PARTS & SERVICE NEWS

Ref.no.	AH04005
Date.	05.07.2004

- Subject:** Modification procedure for engine front cover gasket on 140 engine series
- Purpose:** To introduce modification procedure to repair the front cover gasket of the 140 Series engine in case of repair
- Application:** WA500-3H S/N: H20051 up to H20307; H20312; H20316
- Failure code:** A239AA
- Description:** Introduction
Since there is a possibility of occurrence of oil leakage from the front cover gasket of the engine on WA500-3H, make the modification introduced in this Service News to prevent the above mentioned oil leakage.
- Spare parts:**

Details of the modification

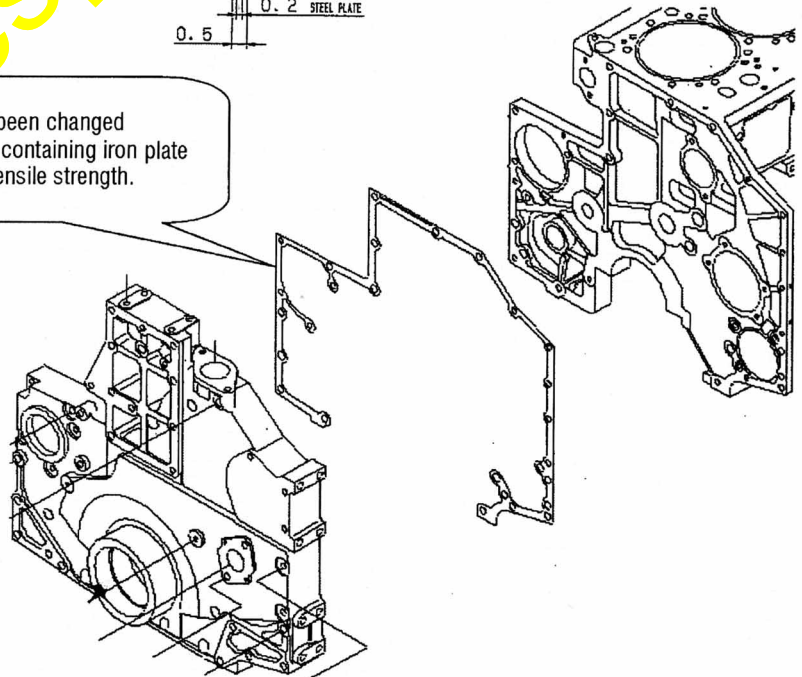
This gasket has been changed to a new gasket containing iron plate to improve the tensile strength.

Modification procedure
Carry out this modification work referring to the Shop Manual.
